Service Advisory: Coil Stop BBR Game: Oktoberfest

SA-12820

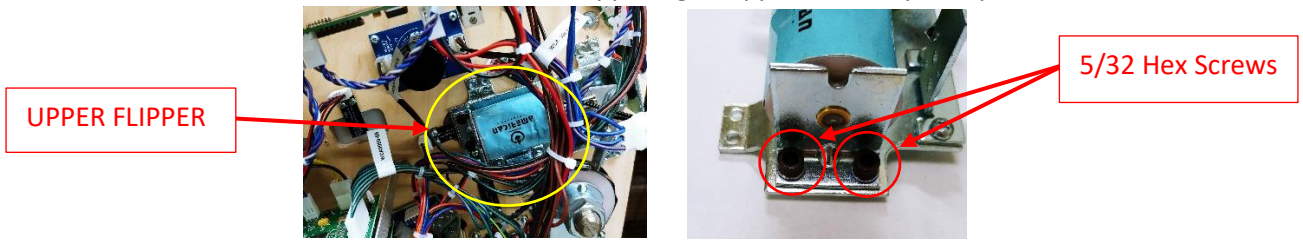
REASON: Reports of Beer Barrel Ramp shot being difficult to make. Testing indicates that shortening the flipper stroke increases odds of making the BBR shot.

6. Remove the two 5/32 hex screws from the upper right flipper assembly. Swap the coil brackets.

P/N SUB0025-01
Longer coil stop insert

7. Replace the 2 hex screws, *don't forget the lock washer on each screw.*
8. Install the playfield glass, lock down bar and close the coin door.
9. Plug the unit in and power up the game.
10. Test the game for as long as needed.
